**HOMESTEAD 2 COMMON SAND FILTER GEC PLANS**

**GRADING EROSION CONTROL PLAN**

HOMESTEAD 2 COMMON SAND  
FILTER GEC PLANS  
DETAILS

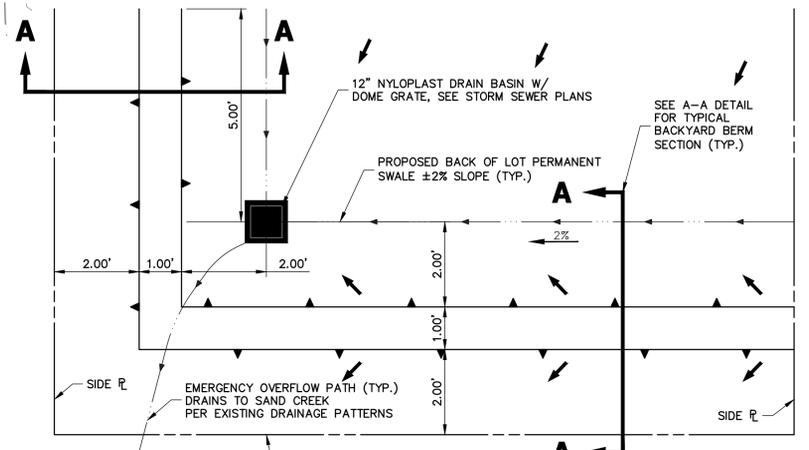
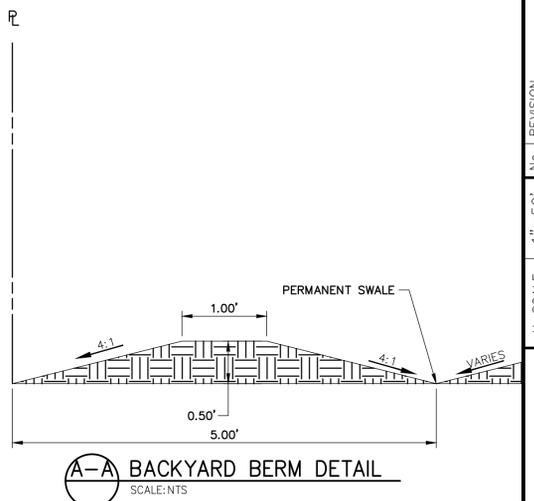
show extent of cut/fill  
show construction boundaries  
and limits of disturbance.

Add LOC line type to legend.  
If "limits of disturbance" and  
"construction boundary" are  
the same, change to  
"construction boundary/limits  
of disturbance" or otherwise  
show as separate linetypes for  
each on the legend and figure.

label as VTC.  
Doesn't seem  
long enough,  
VTC should  
be 75' in  
length

clearly show the extent of the berm and  
add to legend.

Add at least one  
cross-section through each  
sediment filter basin

Show locations and provide details of temporary sediment  
basin, including riser pipe perforation sizing, number of rows,  
required volume, and tributary area to the sediment basin.

**NORTH SAND FILTER  
EMERGENCY SPILLWAY**  
SCALE: 1"=2'

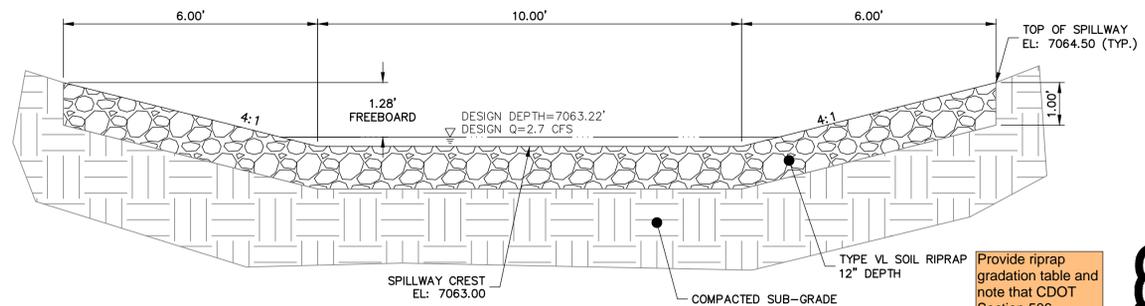
Provide riprap gradation table and note that CDOT Section 506 Requirements apply
